LiDAR QA/QC
– Quantitative and Qualitative Assessment Report –
Jefferson County FL
May 6, 2008

Prepared by:
 **Dewberry**
Fairfax, VA

EXECUTIVE SUMMARY

Figure 9 – Tile 22405850; only ground class is present in the file

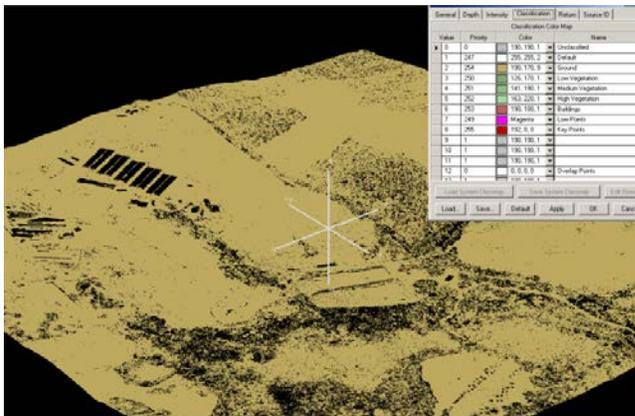
The class review allowed us to identify a tile (22405850) with all the points in class 2 (see Figure 9). A visualization confirmed that this tile was correctly classified as far as the ground is concerned (buildings and vegetation are removed) and would be correct to create a bare earth model. However, all the other classes are missing.

Figure 11 – Tile 22156000 with mosaic of Flightline numbers

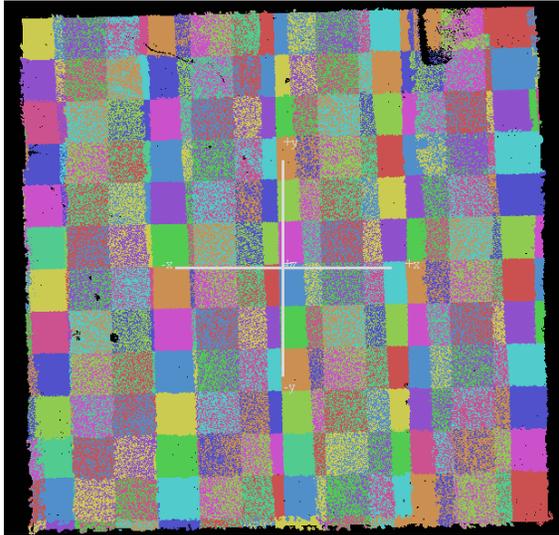
Statistics on the Point Source Id parameter, usually holding the flight line number, extracted 23 files having only one flightline number equal to 1, whereas it was clear that several flightlines were stored in the file (see Figure 12, right), this is a minor issue as no explicit specification was made for this parameter. Another tile (22156000) exhibits an unusual pattern for the flightline id with sections (squares) within a flight line being classified as different flightlines (Figure 11).

Figure 18 – Tile 21305700; Bare earth model colored by elevation. The 3 profiles illustrate a ridge along the flightline edge; actually all the central sections of each flightline (where there is no overlap) exhibit a deltaz of 0.5 foot compared to the overlapping sections.

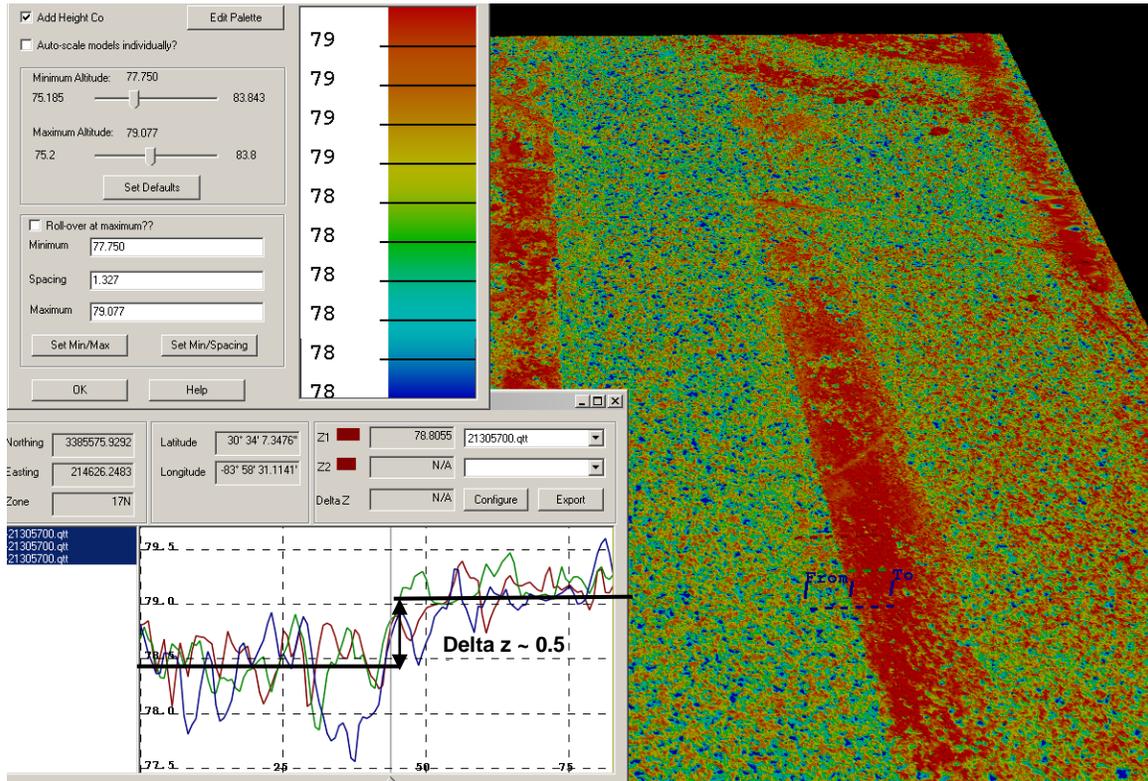
The fact that the flightlines do not completely overlap and that the far edges were not clipped results in recurrent issues in the bare earth model. Indeed, we found a lot of false ridges located exactly along these edges as illustrated in Figure 18. Actually, the central sections of the flightlines (where there is no overlap) sometime exhibit a delta z from 0.25 to 0.5 foot compared to the overlapping sections. If we examine the full point cloud using a cross section as in Figure 19 and Figure 20, we can clearly see that this is due to the fact that more points were available where two flightlines have been acquired and that points located at the edge of a flightline (larger scan angle) were lower than points acquired at nadir. It could be due to a better penetration in the vegetation at a large angle or due to a mirror speed anomaly when it changed direction at the end of a scan.

Figure 20 – Tile 21305100; Full point cloud colored by class, the top cross section shows the point elevation at the edge of adjacent flightlines. Ground points are colored in pink, showing that ground points are higher when only one flightline is available.

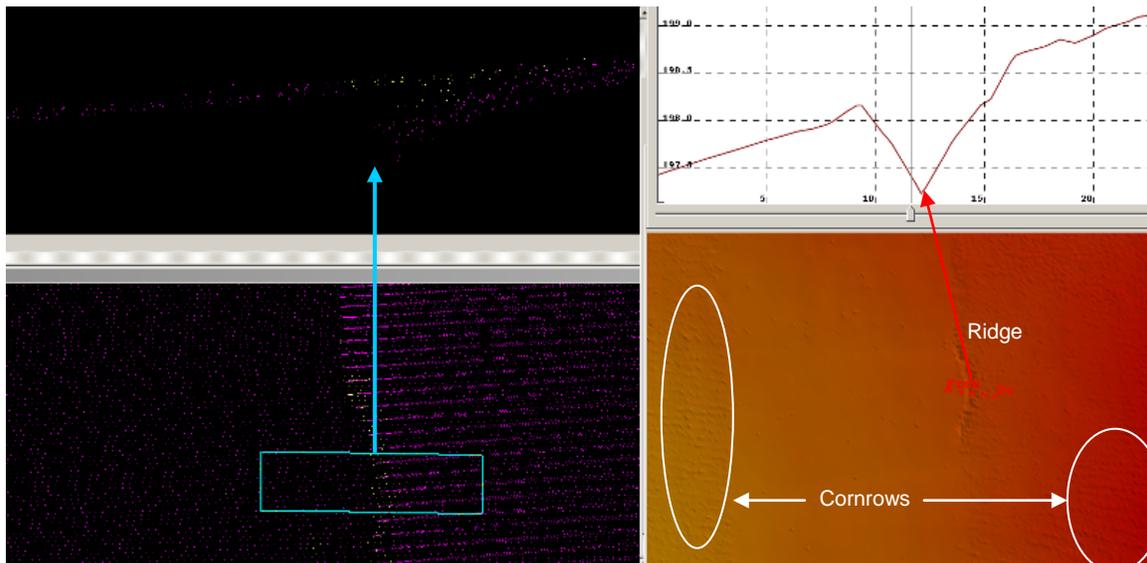
because it is within the noise and accuracy levels. We think that these cornrows are a side effect of the previously mentioned ridges between overlapping flightlines as the cornrows mainly occur along the edges of these flightlines (see Figure 20). Our review found several negligible instances of the cornrow effect as in Figure 21 and the remainder of this effect was within acceptable limits.

Figure 21 - Cornrows under the acceptable limit (0.25feet)

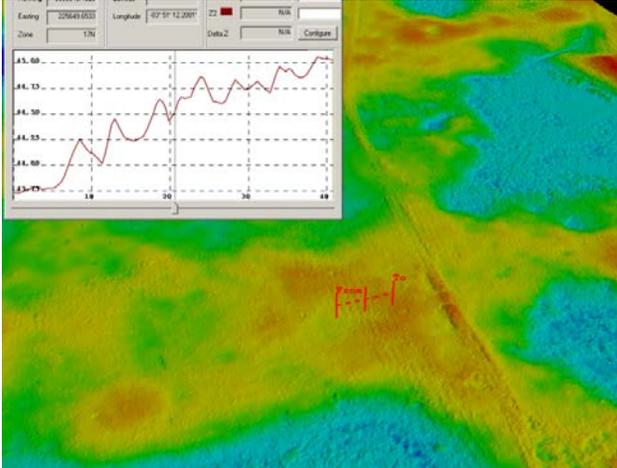
Cornrows were typically seen throughout the project. There are multiple reasons as to why this happens but the end result is that adjacent scan lines are slightly offset from each other. This will give the effect that there are alternating rows of higher and then lower elevations. Although this is common with LiDAR data, as long as the elevation differences are less than 20 cm and the occurrences are minimized, it is acceptable

Figure 23 – Tile 21704700, detail. Sparse density and noise in ground surface due to poor LiDAR penetration in really dense vegetation. The white circle pinpoints the same area in the three images.

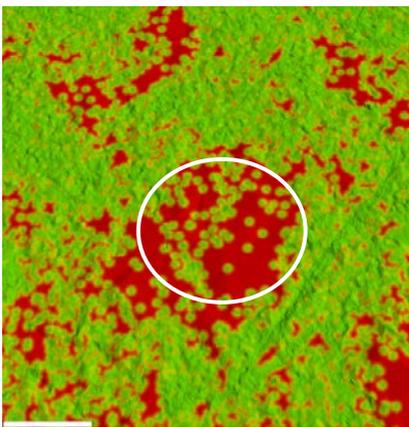
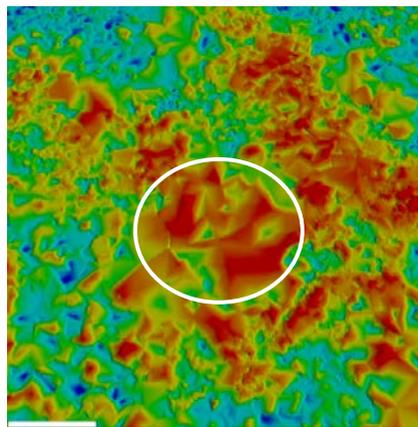
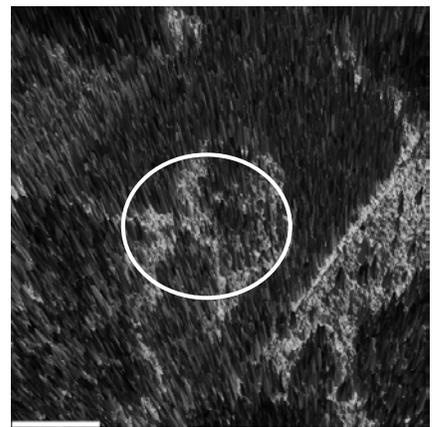
Another problem that we often found is patches with lower density of ground points. When the vegetation is very dense, the LiDAR may not penetrate the canopy all the way to the ground, therefore only a few ground points remain after classification of the vegetation. Nevertheless, as soon as a few points are present, a 3D model can be built with an acceptable reliability, especially in flat areas. However, the smoothness of the surface is often of less quality since low understory vegetation that completely blocks the pulse may be classified as ground resulting in a rather noisy surface. This is illustrated in Figure 22 and Figure 23. Figure 24 shows the corresponding bare earth DEM raster that exhibits the same kind of noisy features and a cross section of the full point cloud clearly proving that dense bushes are blocking the LiDAR.

Figure 25 - Poor LiDAR reflection in swamp area, the LiDAR do not seem to be reflected by the underlying surface.

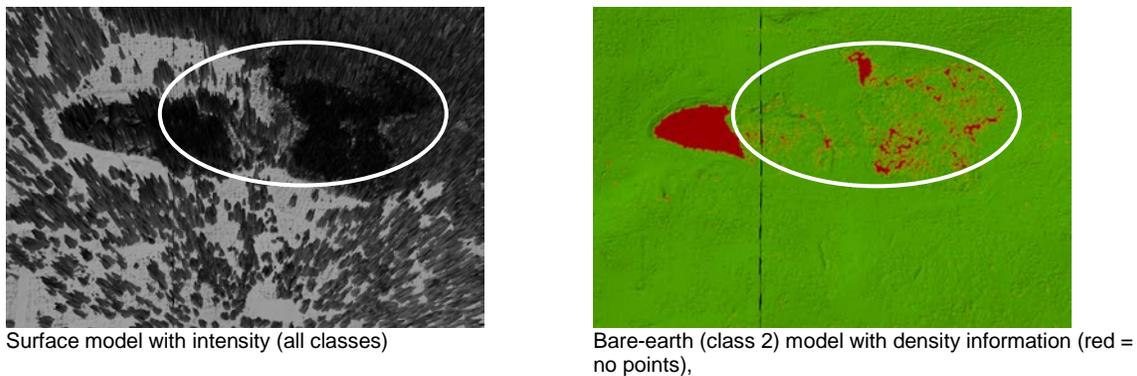
We did find some isolated spots of sparse density of points in the bare earth model with no apparent change in the vegetation density at these locations; however the intensity image is characterized by a darker tone. After carefully inspecting the full point cloud, which really shows presence of LiDAR points inside the vegetation but fewer at ground level and based on the dark coloration of the intensity images we assumed that these are swamp areas where the LiDAR is not reflected by the wet ground surface. Indeed, except at angles close to nadir, the Near Infrared LiDAR beam is usually not reflected by water (Figure 25).

Figure 26 – Tile 21404850. Poor LiDAR penetration, possible vegetation artifacts

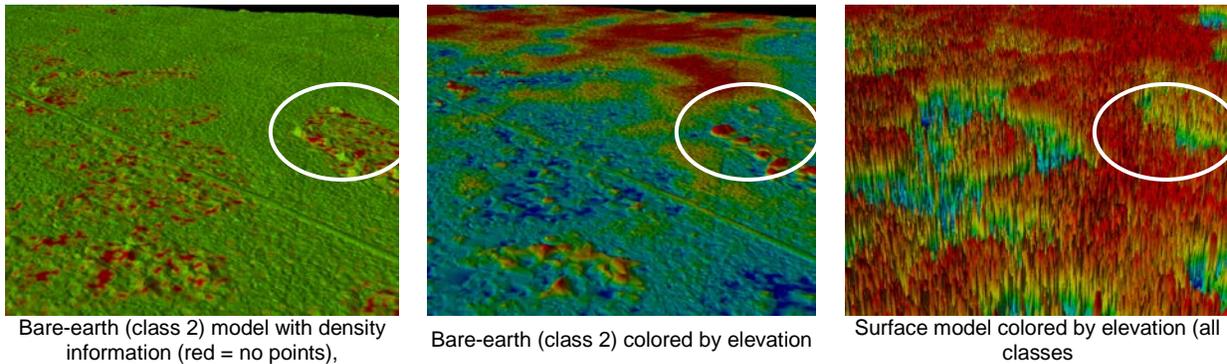
Another classification issue that we encountered is the presence of vegetation artifacts (see Figure 26). Although it is conceivable that the soil exhibits natural small relief, we believe that they are vegetation remains as they occur in areas where we also notice a sparse density of the ground points. These two types of issues are actually linked together; if LiDAR is blocked by the understory vegetation it is more likely that the classification routine treats these last points over vegetation as ground. These artifacts are limited in height but add to the general noise of the bare earth model.

Figure 27 – Inconsistencies in classification (Bare-earth-class 2 model with density information, red = no points)

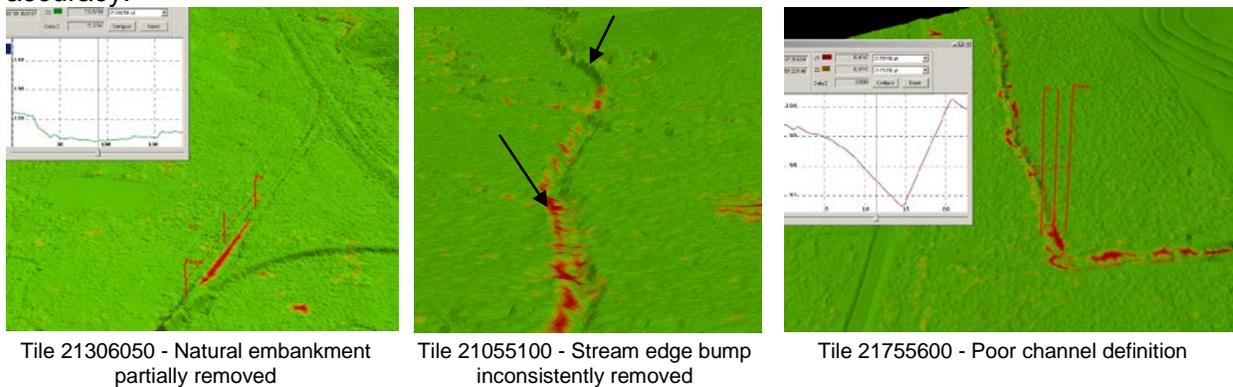
The other classification issues that were observed are inconsistencies in the processing of stream banks or natural elevated embankments. Portions of these features were removed from the ground whereas others are kept. Along stream edges, we also noticed possible aggressive classification; as a result, cross sections of the channel may lose accuracy.
